10/573,449

Office Action Summary	Application No. 10/573,449	Applicant(s) TAKAGUCHI ET AL.	
	Examiner MEGHA MEHTA	Art Unit 1793

DETAILED ACTION

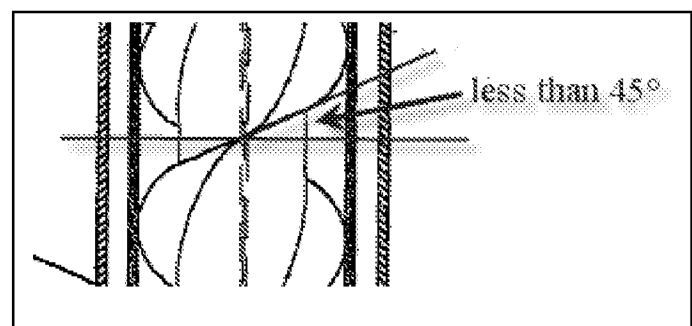
Gerstenberg teaches a multiple-blade screw-type pump has at least 4 helical blades (column 3, lines 63-67) enclosed in a casing that is used to transport a viscous liquid. While Gerstenberg's apparatus is outside Kabe's field of endeavor, it is analogous because both use screw pumps enclosed in cylindrical casings for forcing a viscous liquid through a pump to move it from one location to another. "Thus a reference in a field different from that of applicant's endeavor may be reasonably pertinent if it is one which, because of the matter with which it deals, logically would have commended itself to an inventor's attention in considering his or her invention as a whole," (MPEP 2141.01 Section I).

Regarding claim 11, Gerstenberg teaches that each of the blades overlaps an adjoining one of the blades when the blades are viewed in the axial direction of the impeller (figure 1).

Regarding claim 12, Gerstenberg teaches that the blades are provided at equal intervals in the circumferential direction of the hub (column 3, line 63 -- column 4, line 4), each blade extending around the hub by at least 120° between first and second ends of the blade (figure 1).

Regarding claim 13, Gerstenberg teaches that each of the blades is sloped by at most 45° with respect to a plane

perpendicular to a rotational axis of the hub (shown in figure 1 above).
